NUMBER: 81-4

DATE: 4/1/81

- A. Dual Outboard Installation - Merc 115
- B. Remote Control Sticking In Cold Start Position
- C. Cooling System/Thermostats - V-6 Models

Figure 1. Installing New Components Into Module

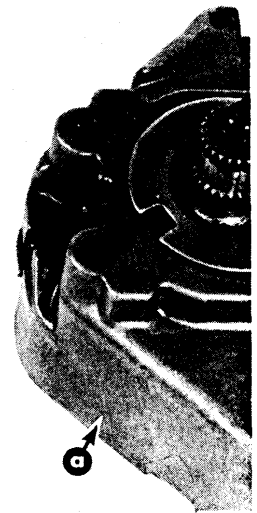
Complaints have been received of the current style (Deluxe and Commander) remote control sticking in the cold start position after starting the engine. To remedy this problem, install Spring and Pin Kit, Part No. C-24-92999A1. (Figure 1) Instructions to replace the spring and pin in the module are included in the kit.
